**Amendment to the Drawings:**

Application No.: 10/714,498

Annotated Marked-Up Drawing

Fig. 1 (Prior Art)

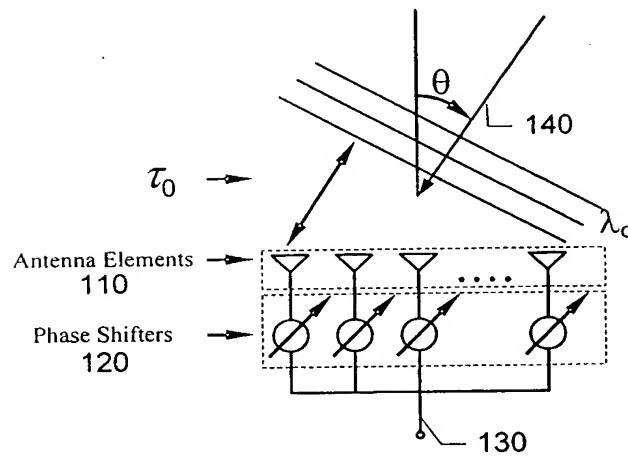
In response to the Examiner's objection to the drawings, please find attached hereto a Replacement Sheet and an Annotated Drawing Sheet for Figure 1 which adds the caption "Prior Art" to Figure 1.

As an initial matter, Figure 1 was objected to in the Office Action because it did not include the caption "Prior Art". Applicants have attached hereto a Replacement Sheet and an Annotated Drawing Sheet which add the caption "Prior Art" to Figure 1. Accordingly, entry of the revised Figure 1, and reconsideration and withdrawal of the objection thereto, are respectfully requested.
